ST. TAMMANY PARISH

Addendum No.: 1

Bid#: 20-6-2

Project Name: I-10 Service Road Bridge Replacements

DRAINAGE DETAILS FOR
 CONCRETE APPROACH SLABS
 SLAB SPANS AND QUAD BEAM BRIDGES
 BD.2.10.1.0.07 - APPROACH SLAB COMMON
 BRIDGE AND STRUCTURAL DESIGN

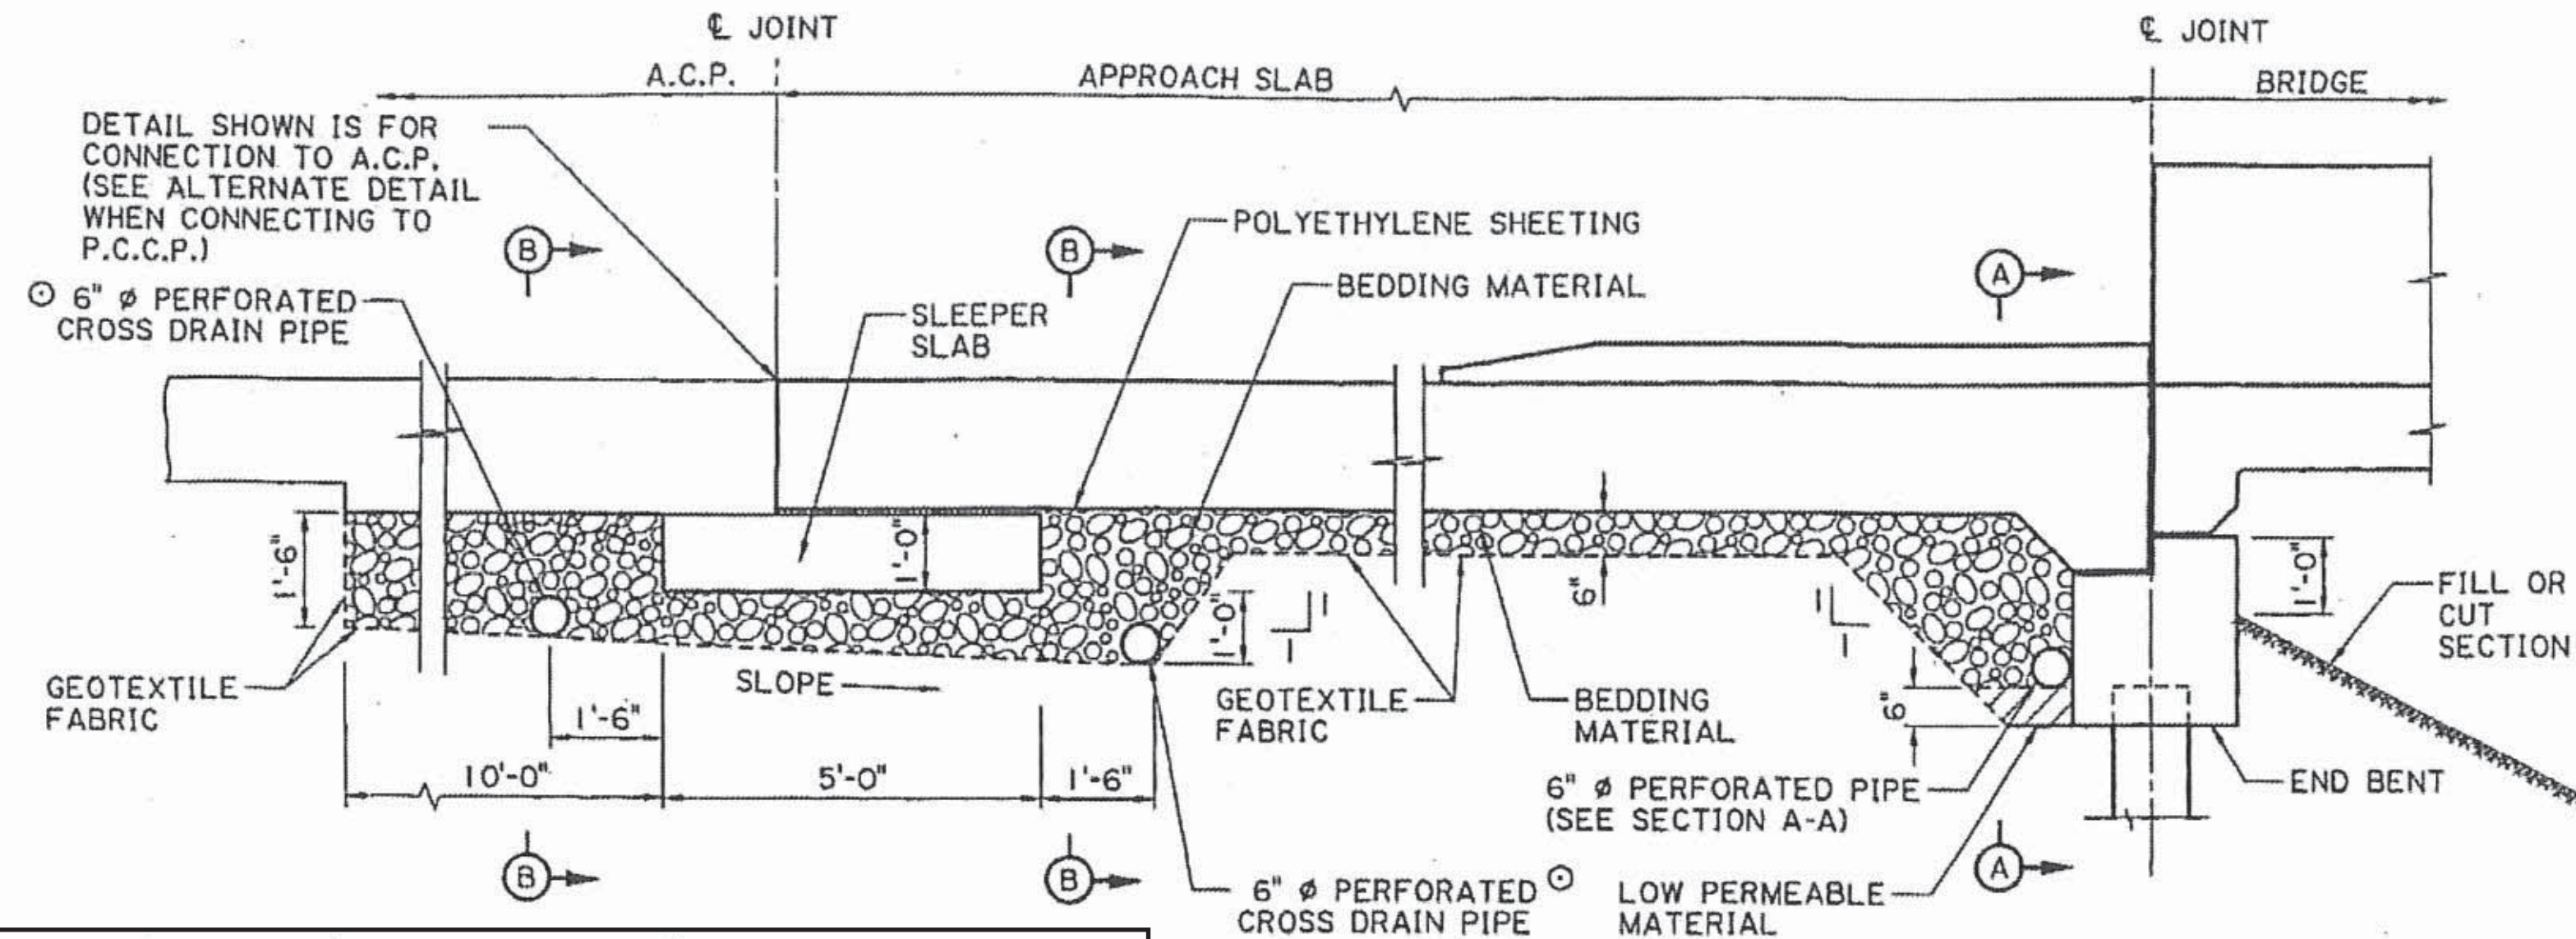
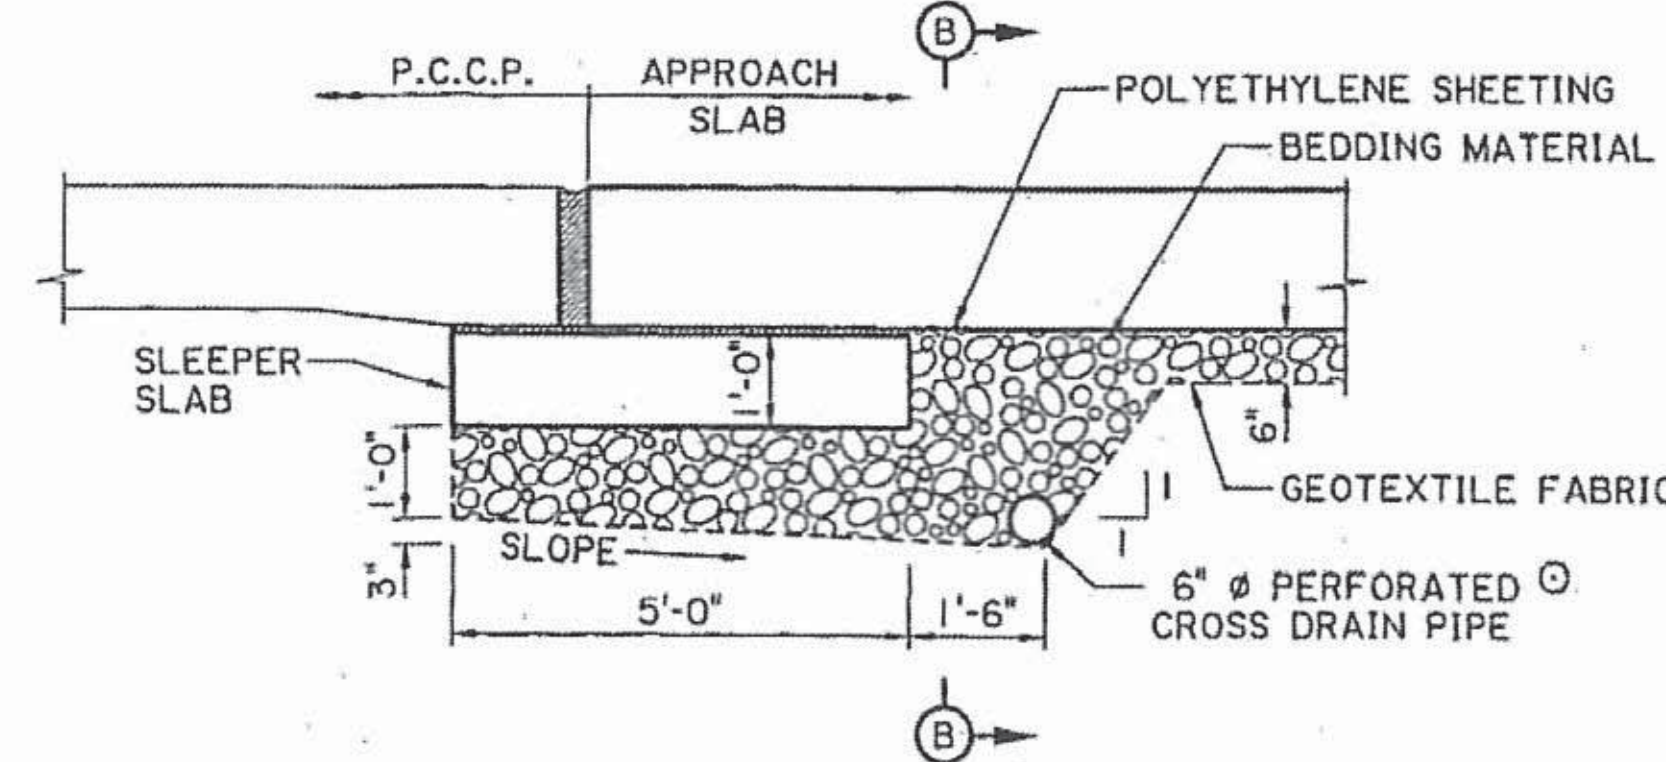
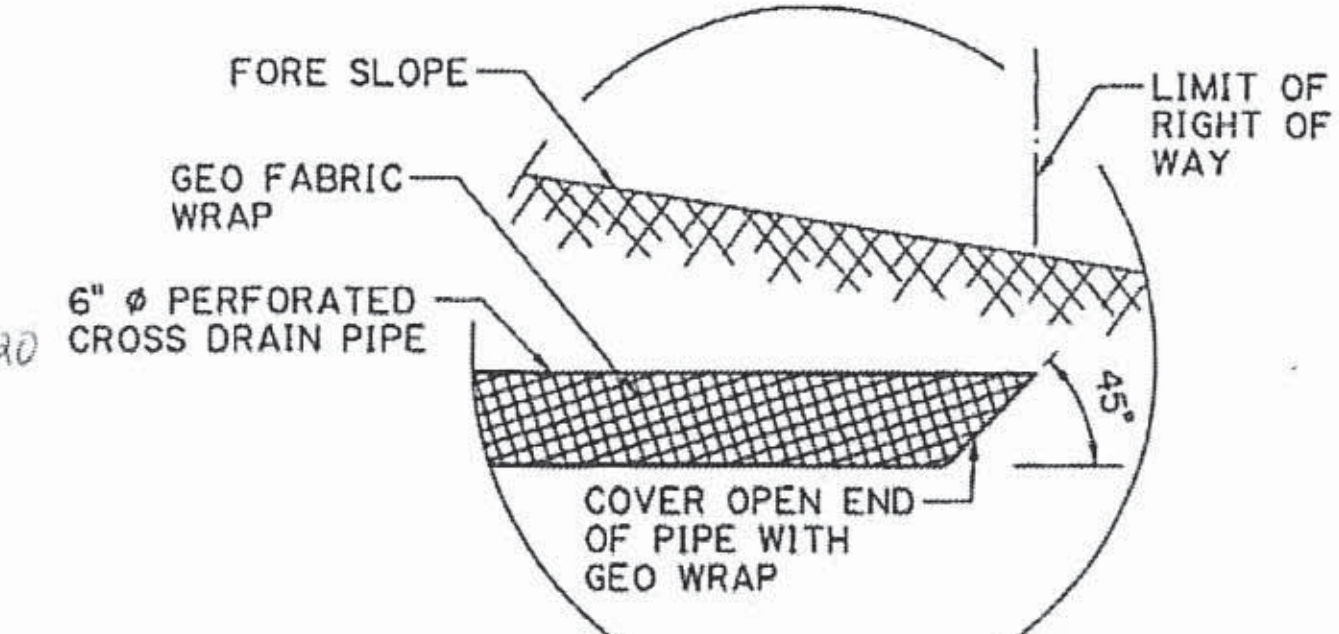
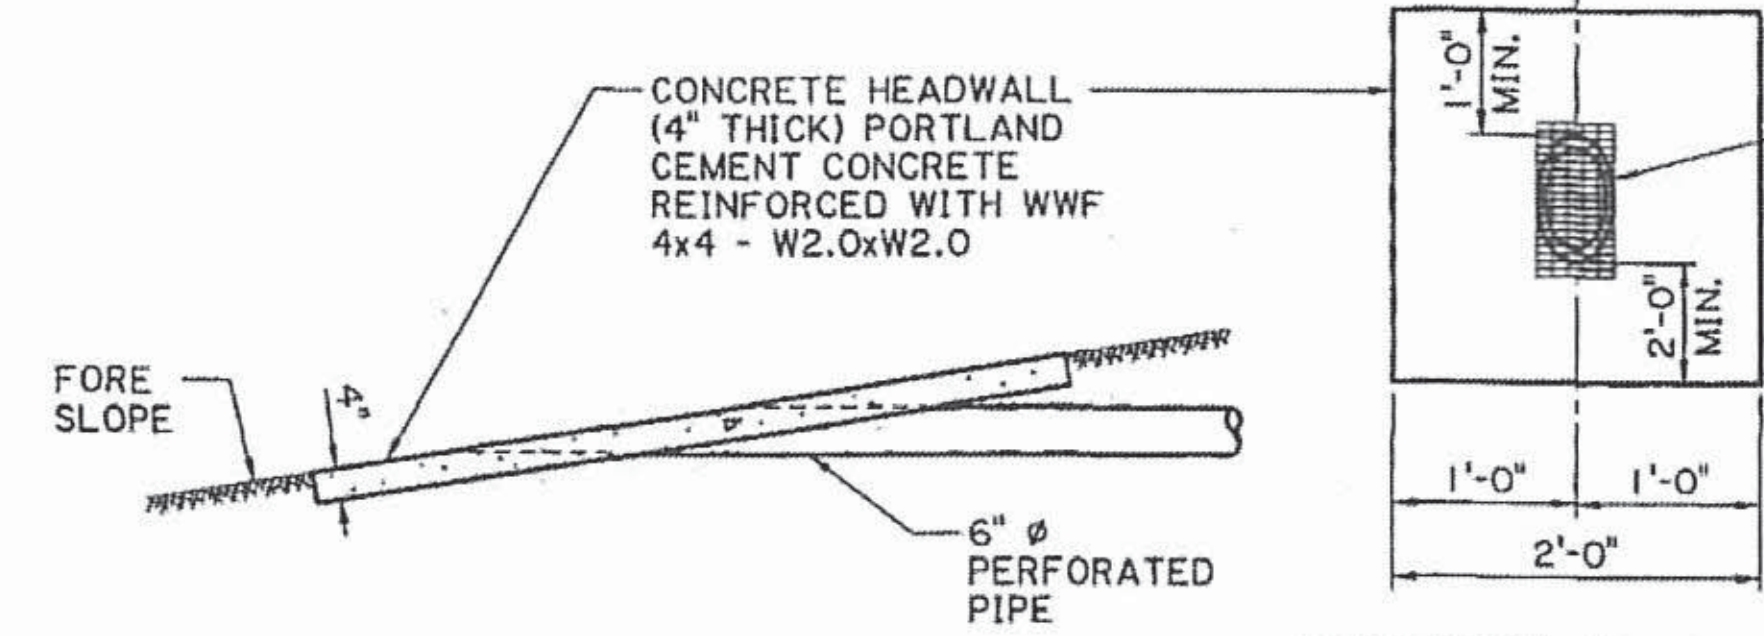
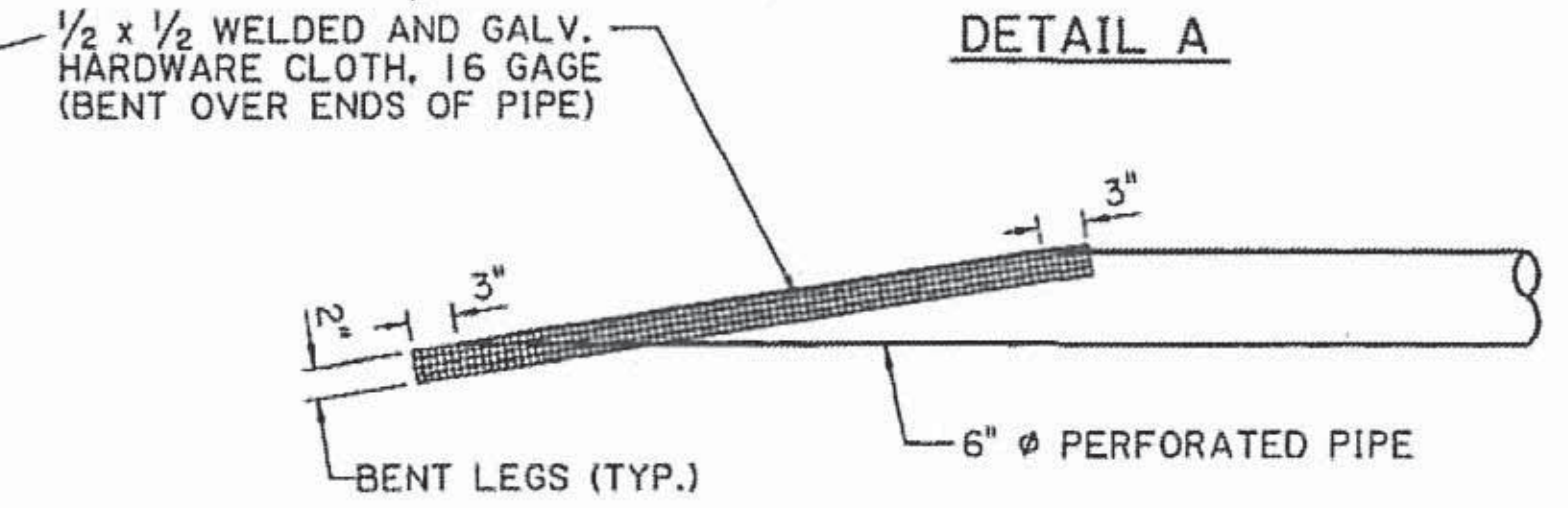
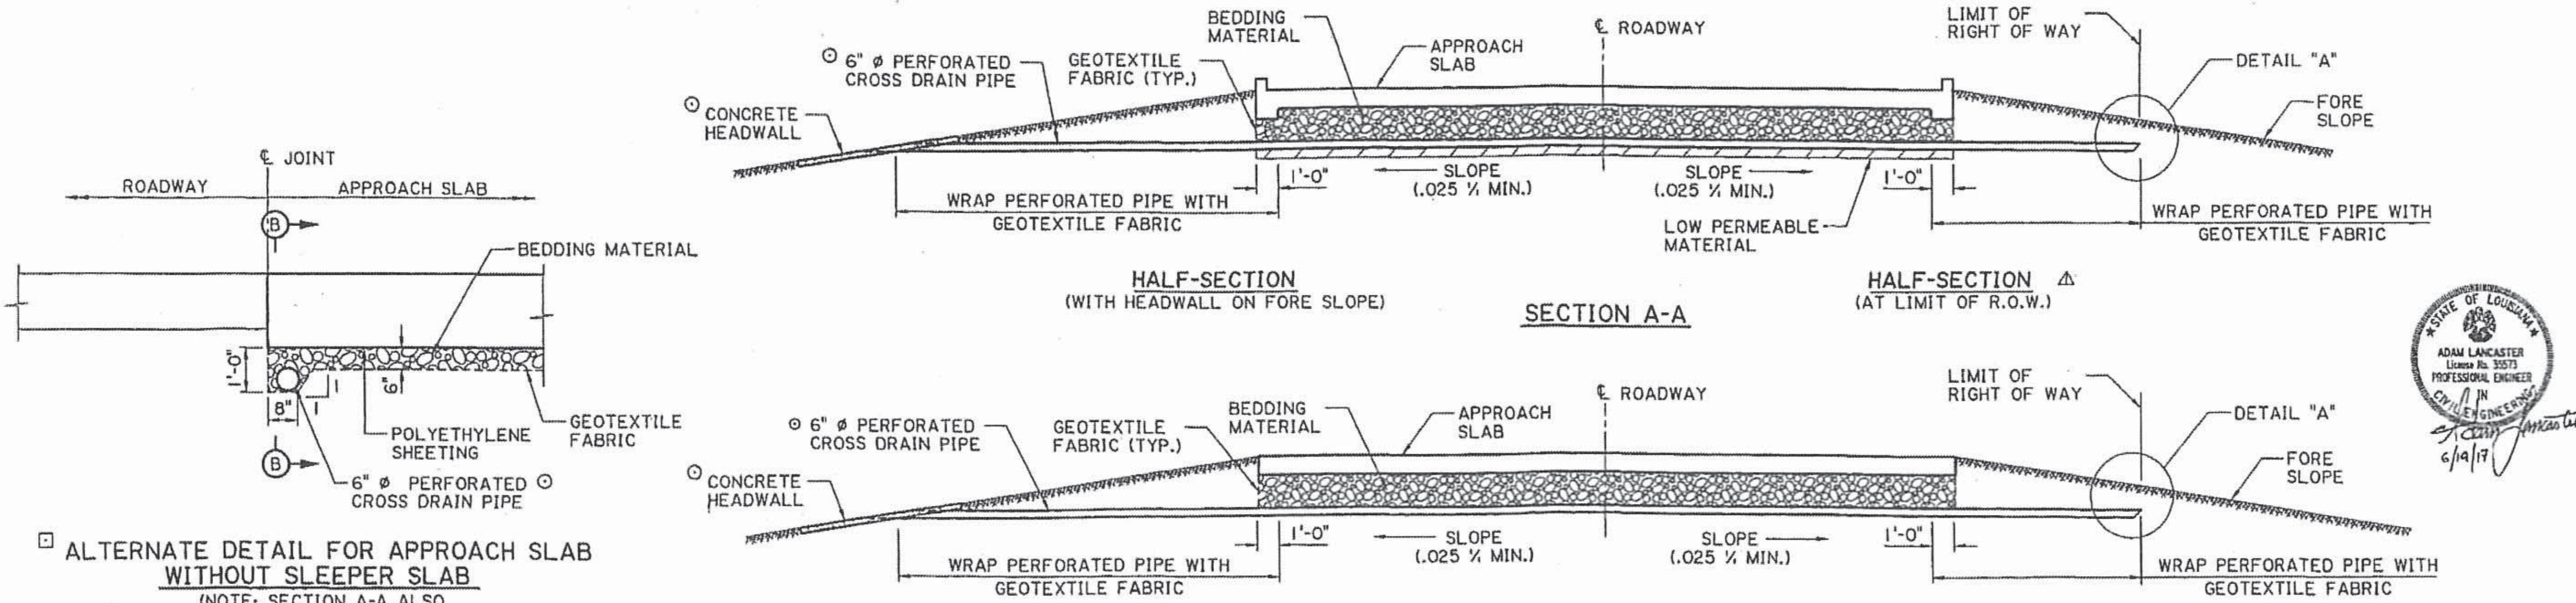
Question 4: Can you clarify that this is an off-system bridge and that no sleeper slab is required under the approach slab sheet 341?

Question 6: Is there a standard available for the yard drain?

Answer 4: A 5' long by 12" deep sleeper slab will be required at each approach slab per sheet number 341. Reinforcing steel shall be #5 bars @ 9" spacing top and bottom each way.

Answer 6: See plan sheet 341, LADOTD standard specification section 703, material specification section 1006, and LADOTD Underdrain and Yard Drain Systems approved materials list.
